**SUSQUEHANNA STEAM ELECTRIC STATION  
RESPONSE TO REQUEST FOR ADDITIONAL  
INFORMATION ON AMENDMENT REQUEST  
NO. 299 FOR OPERATING LICENSE NO. NPF-14  
AND AMENDMENT REQUEST FOR OPERATING  
LICENSE NO. NPF-22: PRA QUESTIONS  
PLA-6473**

**Docket Nos. 50-387  
and 50-388**

**ATTACHMENT 1 TO PLA-6473**

**RESPONSES TO REQUESTS FOR ADDITIONAL  
INFORMATION**

### Unit 1 LERF (HE) Contribution By Sequence

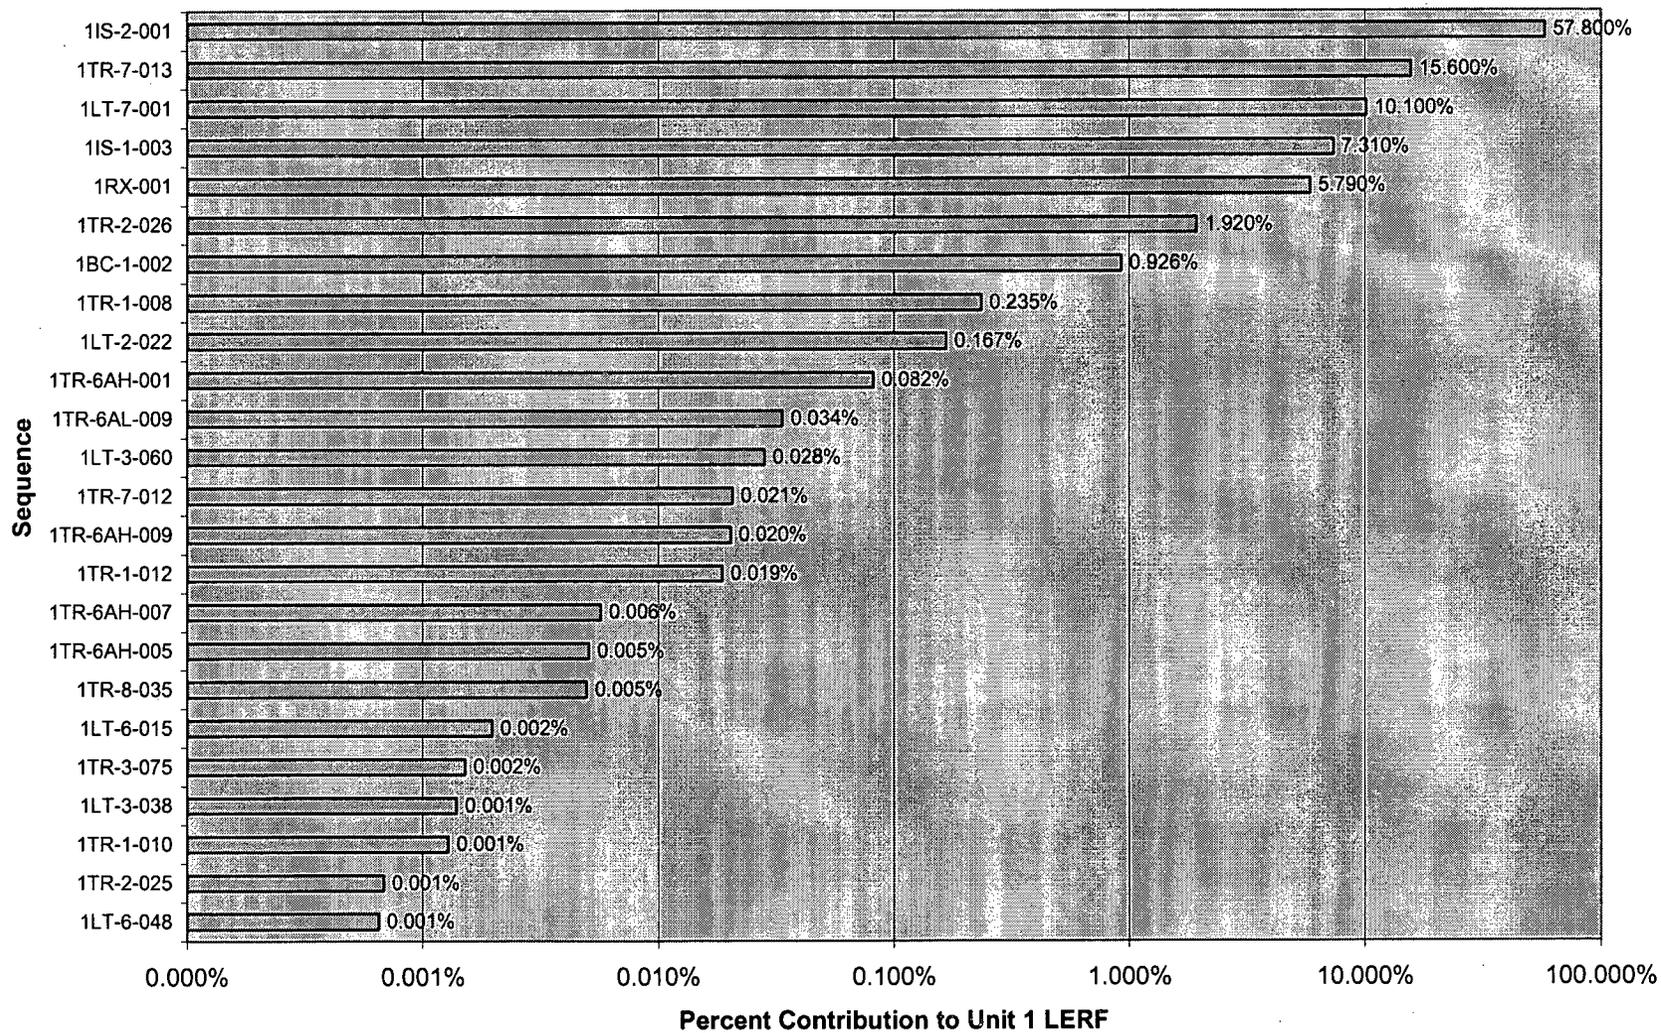
It is stated in Section 4.4.2 that the majority of postulated containment failures involve catastrophic containment over-pressure failures, which are also predicted to fail secondary containment, thereby rendering SGTS ineffective. Explain why use of the containment vent in accordance with SSES's plant-specific implementation of the BWROG Emergency Procedure and Severe Accident Guidelines (EP/SAGs) is not effective in reducing the overall contribution from containment over-pressure failures. The explanation may take the form of discussing the top LERF sequences and why venting does not reduce the containment failures. (The generic EP/SAGs direct containment venting irrespective of dose in order to prevent containment failure.) If this statement is the result of the SSES PRA treating containment venting in a different manner than directed in the plant-specific EP/SAGs, provide a re-characterization of: (1) severe accident containment response/failure assuming appropriate credit for containment venting (i.e., operator actions consistent with the plant-specific EP/SAGs), and (2) the effectiveness of SGTS in reducing severe accident releases/risk assuming appropriate credit for containment venting.

## **Question 2**

Explain how paragraph 4.2.2 of the submittal is consistent with License Renewal SAMA #12 and response to RAI 1.G in Reference 2.

Given core damage has occurred, venting or not venting primary containment does very little to the Large Early Release Frequency (LERF). As seen from the bar graph and table below, 99.4% of the LERF is unaffected by primary containment venting.

SAMA #12 recognizes that given core damage, venting primary containment may not be likely using the SSES Emergency Operating Procedures, although the procedures do not prohibit venting. The SAMA evaluates crediting venting, with the benefit of scrubbing, after core damage. This SAMA also assumes the vent can be opened. The SAMA identifies all the sequences that can benefit from venting. A review of these sequences resulted in only one sequence, 1TR-6AH-001, that was a large early release sequence. This one sequence (if venting were credited) would go to a low early release. As can be seen from the bar graph, this sequence represents an insignificant, 0.082%, amount of the total LERF.
